MONTGOMERY COUNTY HISTORIC PRESERVATION COMMISSION
STAFF REPORT

Address:	9838 Capitol View Ave. (Lot 12, Block 31) Silver Spring	Meeting Date:	9/07/2022
Resource:	Spatial (undeveloped) Capitol View Park Historic District	Report Date:	8/31/2022
Applicant:	Mark Kaufman (Doug Mader, Architect; Phillip Long, Engineer)	Public Notice:	8/24/2022
Review:	HAWP	Staff:	Dan Bruechert
Case No.:	960660	Tax Credit:	n/a
Proposal:	Construction of new single-family residence, site alteration, hardscape alteration, and tree removal

Staff recommends the HPC **approve with two conditions** the HAWP application:

Revisions:

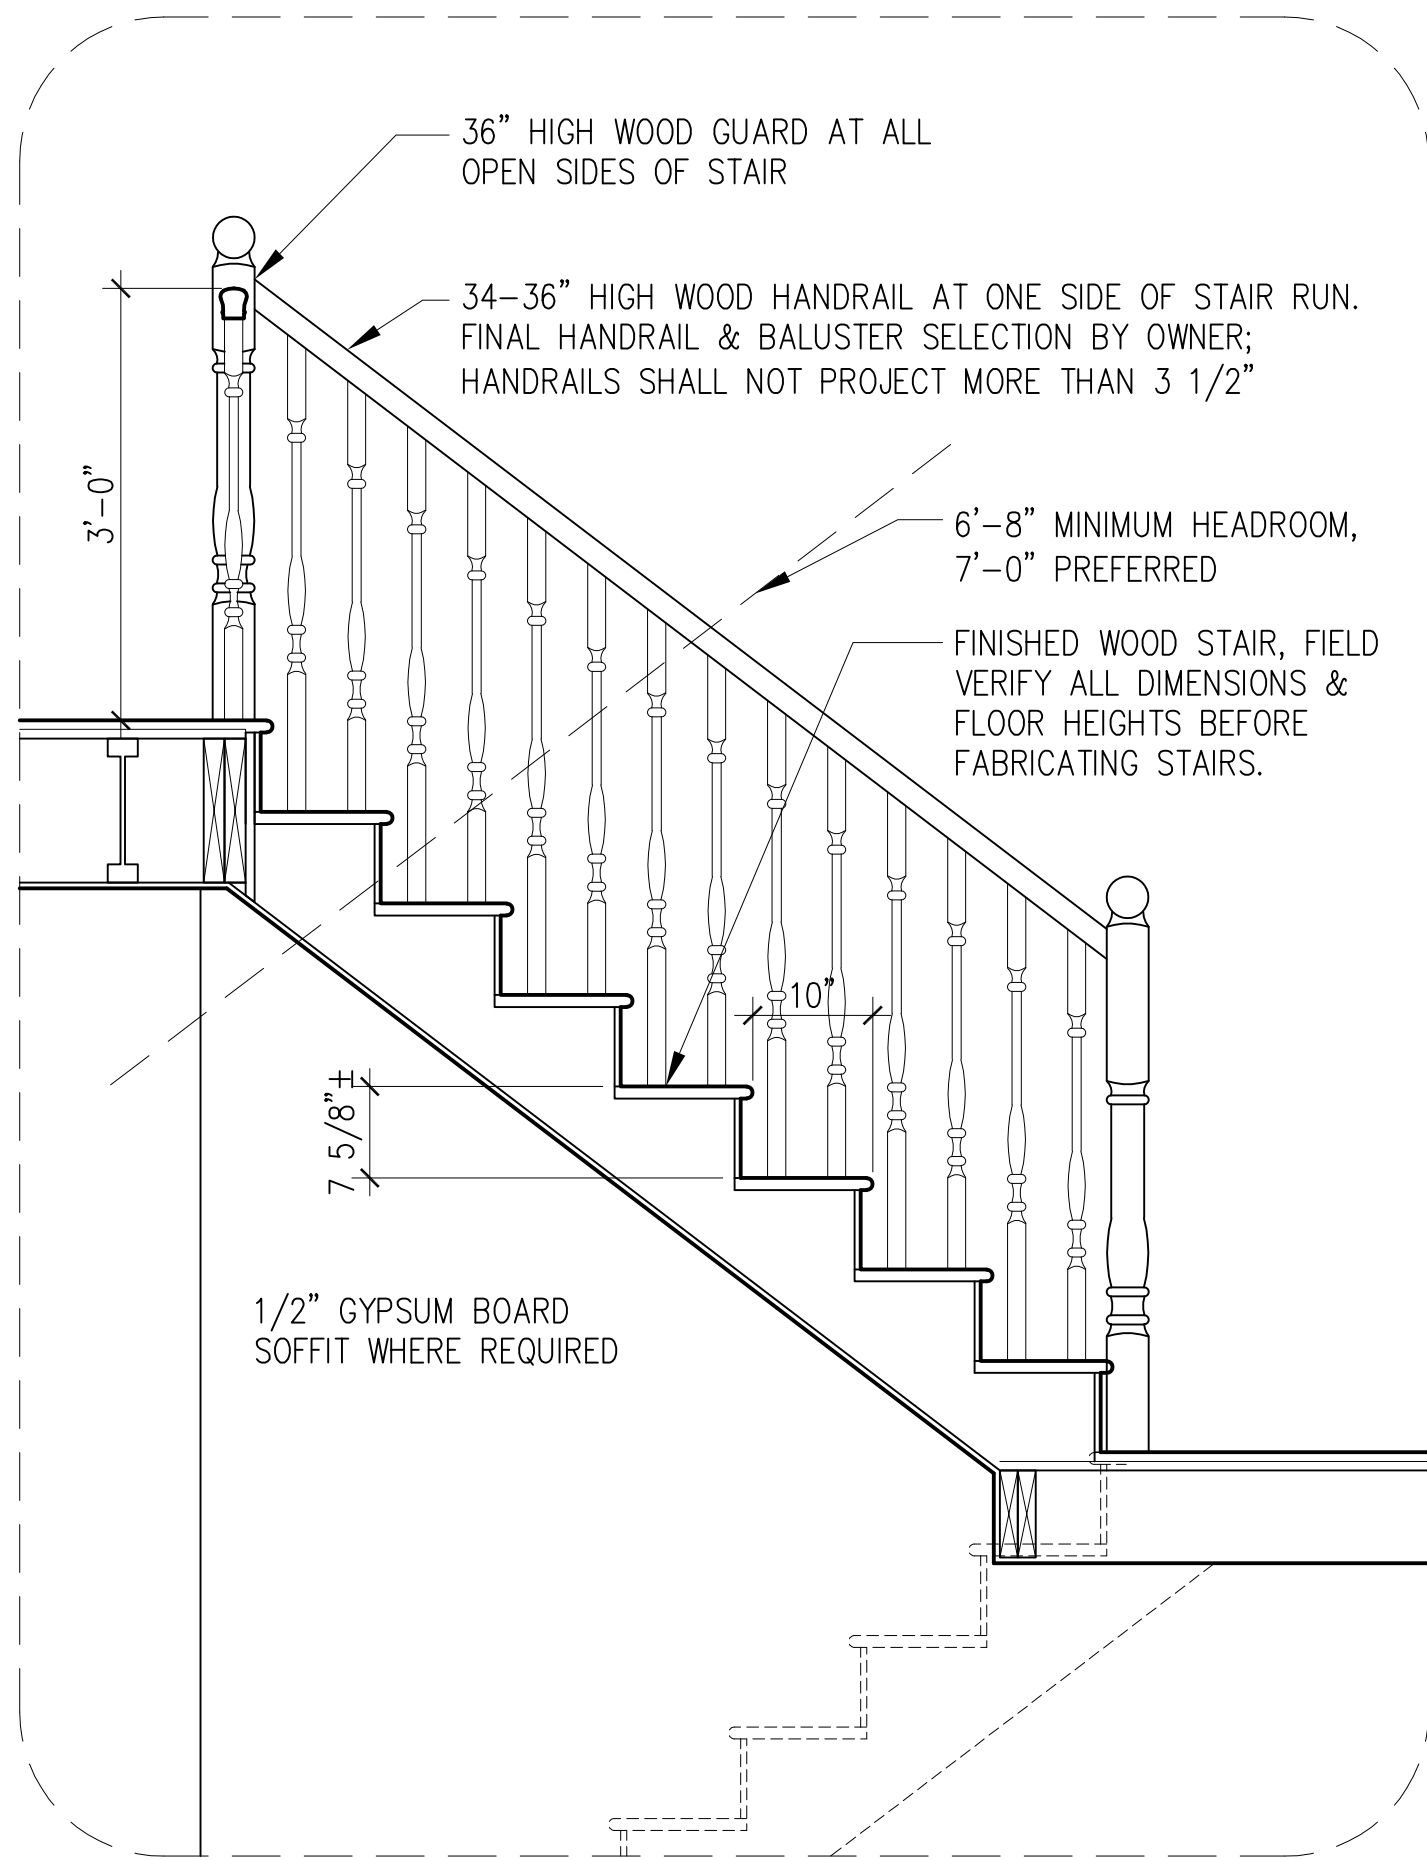
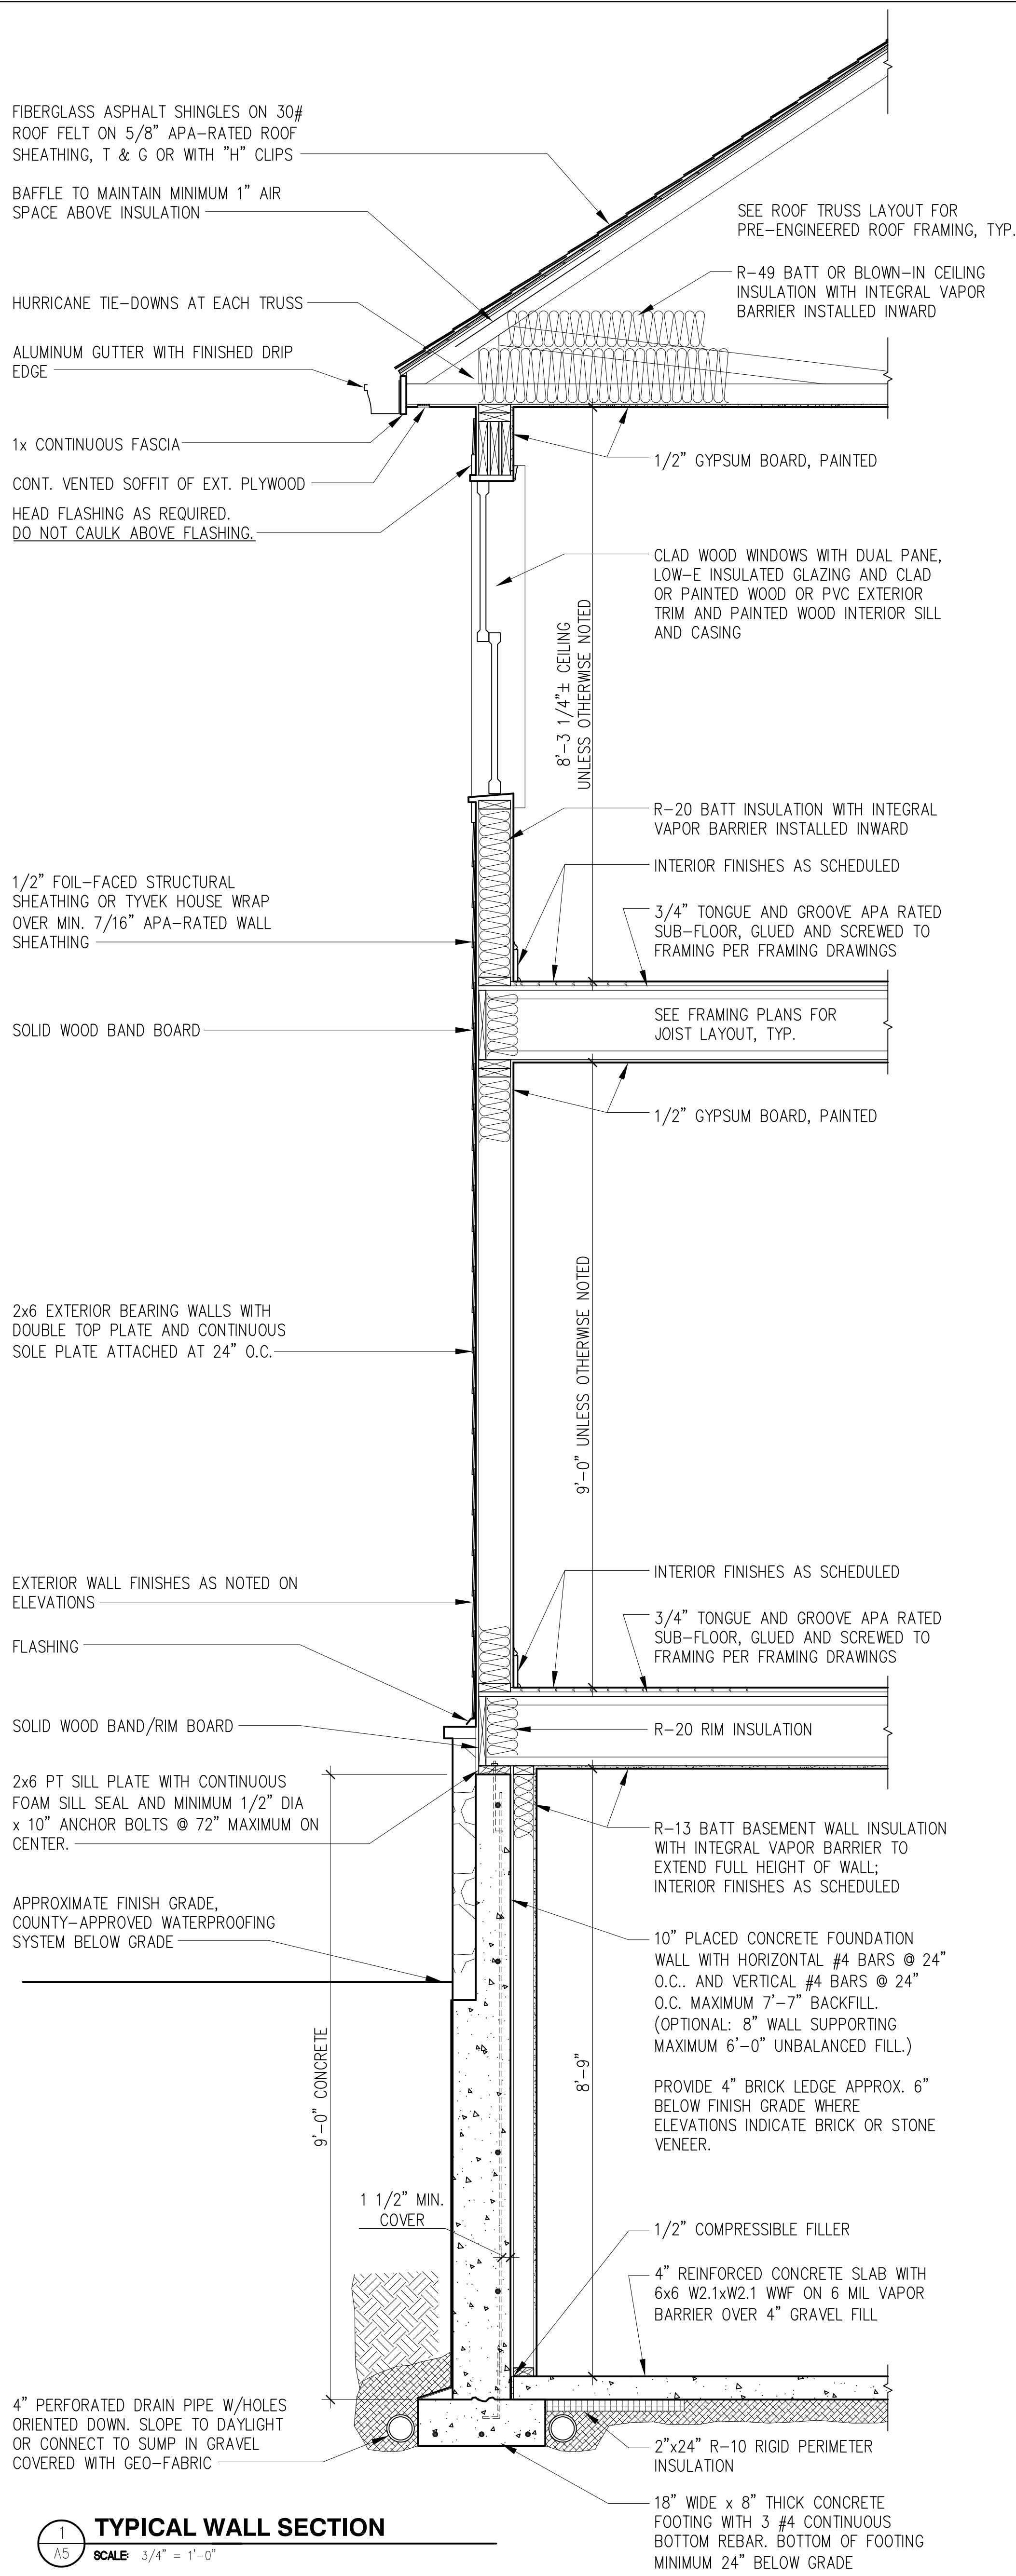
The house is two stories tall and the main block of the house is approximately 35’ × 40’ (thirty-five feet wide by forty feet deep) with a front telescoping, two-car garage that is approximately 20’ × 30’ (twenty feet wide by thirty feet deep). While most of the surrounding houses are one or one and a half stories tall, the proposed two-story construction will not have a significant impact on the streetscape because of the significant change in grade and deep setback. Staff also finds that the proposed house appears slightly wider than many of the neighboring houses on the west side of Capitol View Ave., but not to the extent that it detracts from the surrounding streetscape (see attached streetscape study).

The house draws largely from a traditional architectural vocabulary and have a front gable roof, with a

small front porch with a shed roof. The house has projecting rectangular bays on each side elevations to break up the massing. The proposed house has a large wood deck at the rear. The windows are mostly six-over-one sash windows, with some single lite casements, and picture windows.

The one element that deviates from traditional architectural design is the two-story, front-telescoping attached garage. To accommodate the existing driveway, the house on the subject lot will be front loading with carriage-style doors. At the Preliminary Consultation, Staff found the garage form was not compatible with the surrounding architecture and, absent a compelling reason, should be excluded from the design. During the hearing, the applicant detailed the need to utilize the existing driveway for not only the subject house, and the Carson House, but for the future construction on Lot 13 (to be submitted at a future date).

Staff agrees with the finding of the majority of the Commissioners, that the house is on the large size for the district, but it is not out of character with nor does it overwhelm the houses in the surrounding district. For example, the most recent construction on Capitol View Ave. (9905 Capitol View Ave., approved in 2015) has a footprint of 35' 8" × 50' 11" (thirty-five feet, eight inches wide by fifty feet, eleven inches deep). That construction includes an integrated two-bay garage, which is accessed from Menlo Avenue.

The HPC found the materials proposed are consistent with what is typically approved for infill construction in the Capitol View Historic District. These materials include fiber cement clapboard and fiber cement shingle siding, clad wood windows, and an architectural shingle roof. Staff concurs with the HPC finding that these materials are appropriate for the site and district, however, window specifications were not included with the HAWP submission. Staff recommends the HPC delegate final approval authority for the clad (or wood) windows and doors to Staff.

1. Three shade/canopy trees need to be planted in front of the proposed house, between the house and the public right-of-way. A site/landscape plan satisfying this condition needs to be submitted with the permit drawings before Staff can issue the HAWP approval;
 2. The windows and doors need to be wood or aluminum clad wood. Final approval authority is delegated to Staff to determine the selected windows and doors are appropriate;
- under the Criteria for Issuance in Chapter 24A-8(b)(2), and (d), having found that the proposal is compatible in character with the district and the purposes of Chapter 24A;
